Staff Report

To: Salt Lake City Planning Commission
From: Katia Pace, (801) 535-6354, katia.pace@slcgov.com
Date: February 3, 2022
Re: PLNHLC2021-01144 – Major Alterations @ 229 N Almond Street

Major Alteration

PROPERTY ADDRESS: 229 N Almond Street

Footprint of the attic. Showing the width of the dormer and of the staircase.

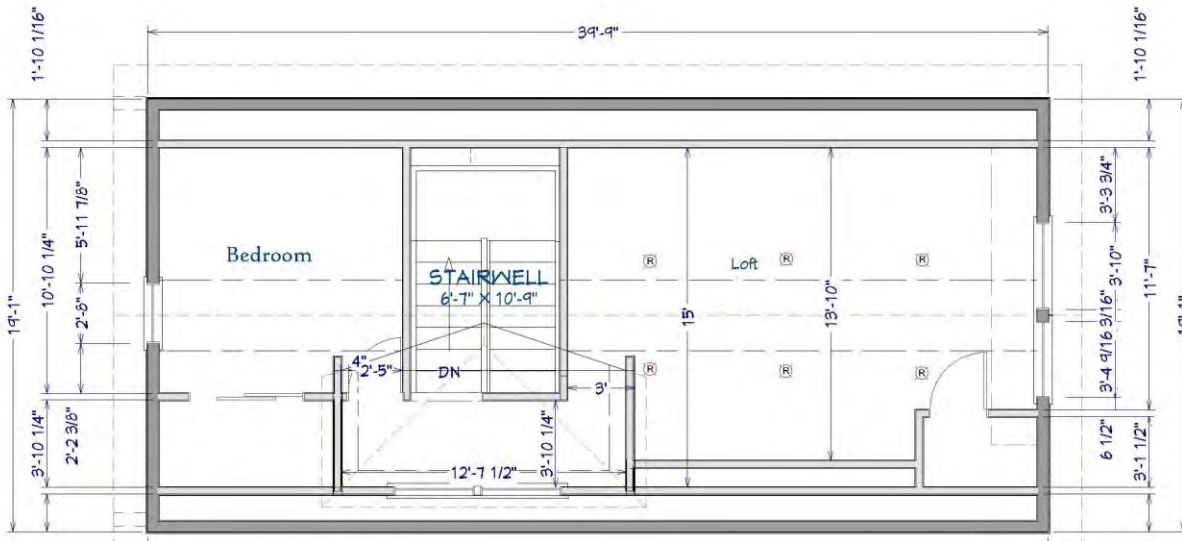
As part of the renovation, the attic was turned into a livable space. A dormer was constructed/added to the house to accommodate a set of interior stairs to the attic. The dormer was built with a pitched roof that does not match the pitch of the house, the pitch on the dormer is a lot flatter in comparison with the pitch of the house. The dormer is very wide and has a horizontal orientation. The roof ridge of the dormer is of the same height as the roof ridge of the house. The siding of the dormer is vinyl and the window on the dormer is a sliding vinyl window.

The width and the height of the dormer was for the landing of the new stairs to meet current IBC standards. The applicant will relocate the staircase and use the internal space of the attic to accommodate the stairs.

Proposal: The applicant proposes to remove the dormer on the North elevation and restore the roof to its original form.

Findings: Dormers need to be designed to be compatible with the size, scale, material and character of the property, neighborhood, or environment.

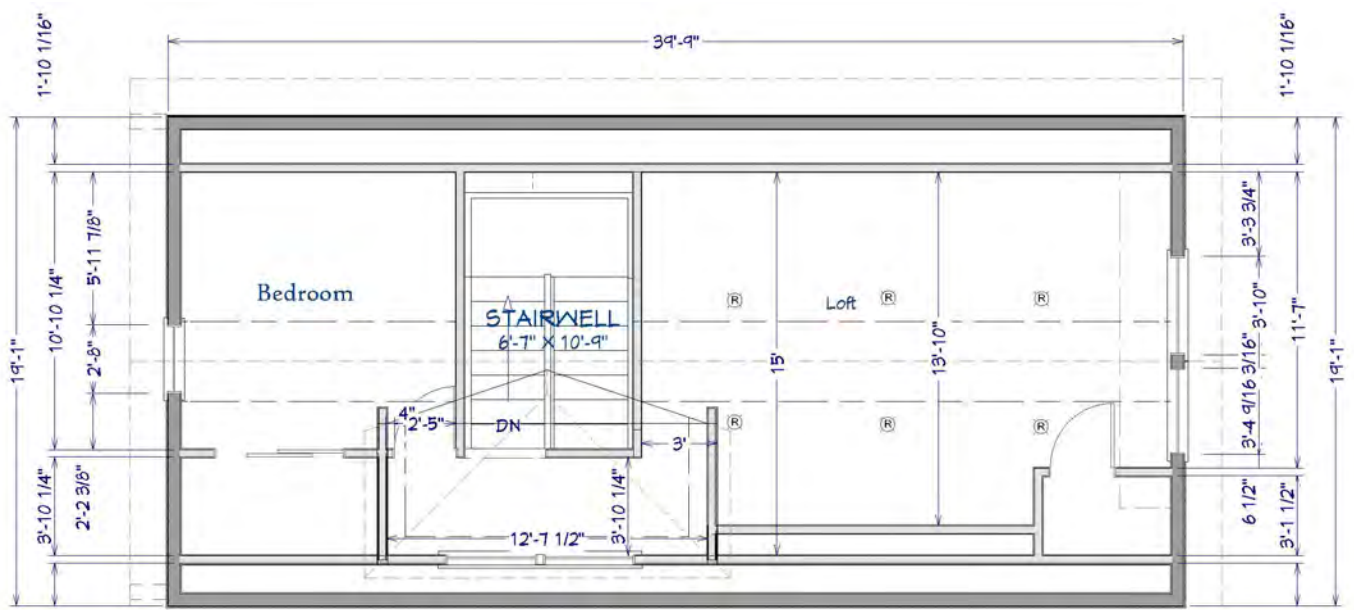
As part of the renovation, the attic was turned a livable space. A dormer was constructed/added to the house to accommodate a set of interior stairs to the attic. There was a previous stair that accessed the attic, but according to the applicant it was too narrow, the rise was too steep, and there was not enough head room at the top with the current roof and

The dormer was built with a pitched roof that does not match the pitch of the house, the pitch on the dormer is a lot flatter in comparison with the pitch of the house. The dormer is very wide and has a horizontal orientation. The roof ridge of the dormer is of the same height as the roof ridge of the house. The siding of the dormer is vinyl and the window on the dormer is a sliding vinyl window.

The proposed hip roof is a positive change because it relates to the roof on the porch of the house and it lowers the height. The proposed changes to the siding and window are also positive. However, staff finds that this dormer, even with the proposed changes, would not be subordinate to the roof and the scale of the home.

1. Change the roof shape from a pitch roof to a hip roof, to echo the hip roof at the front of the house. That would be in keeping with some of the roofline and would reduce some of the height of the dormer.
2. Change the siding of the dormer from vinyl to wood lap siding.
3. Change the one vinyl/slider window of the dormer with two double hung wood windows side by side.

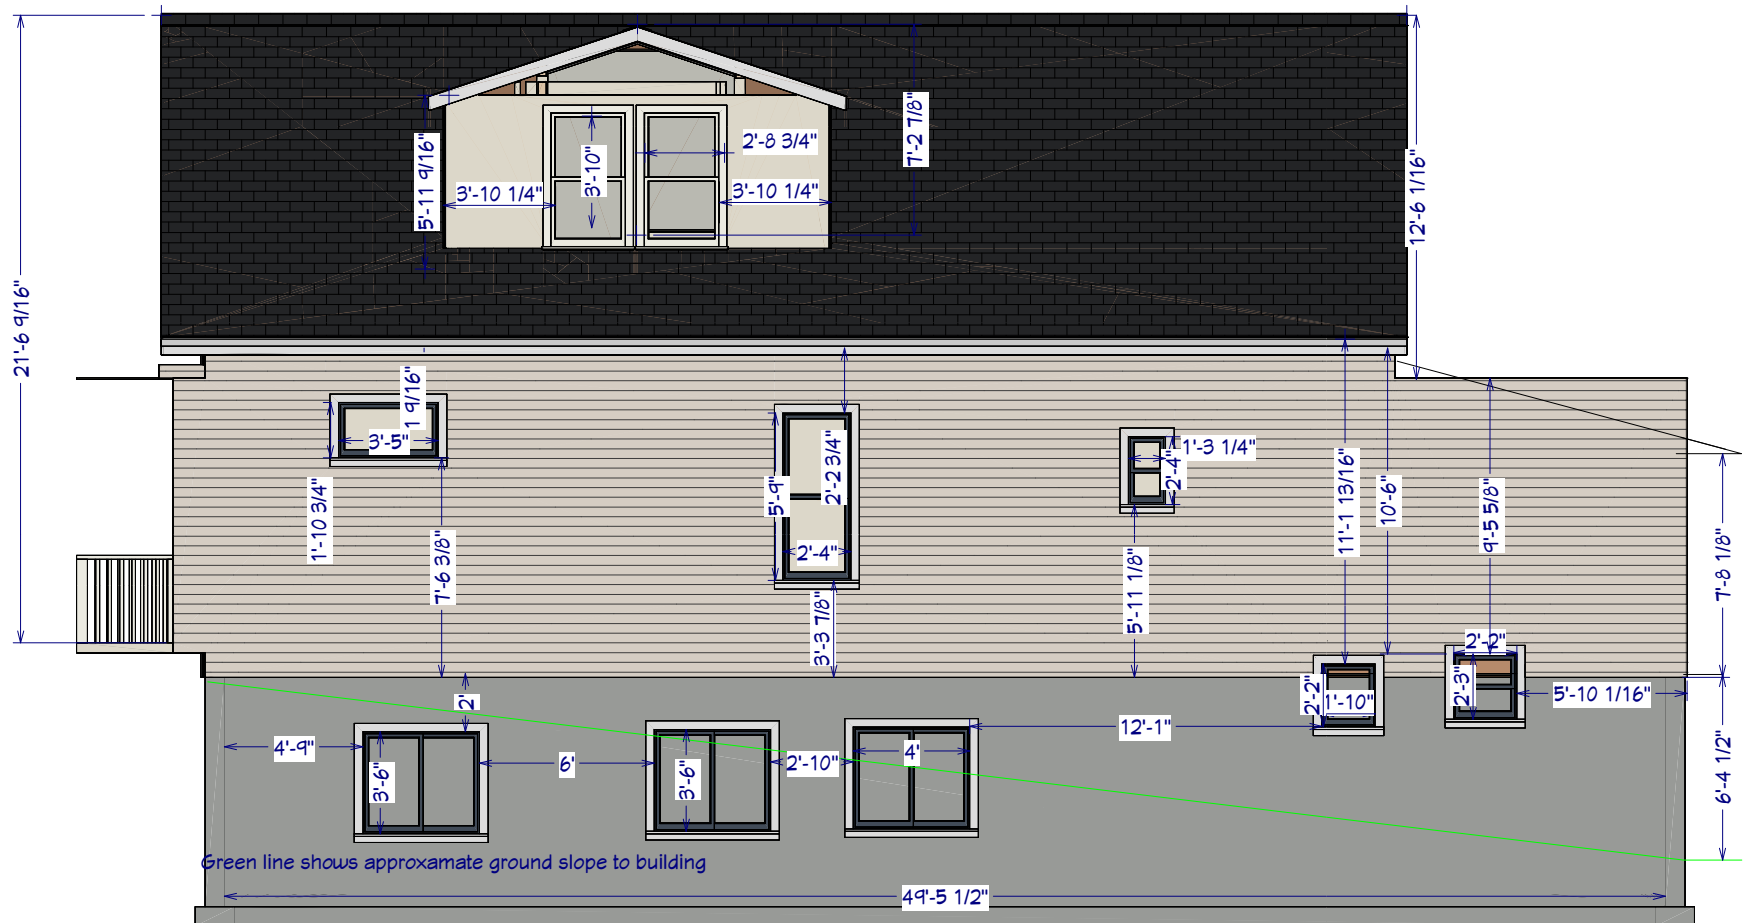
The terrain slopes from the front of the house at the top of the foundation to completely exposing the foundation wall just before the addition

Addition has shed roof , because of software limitations I cannot render the roof in this drawing.

Lower elevation is 14' above grade
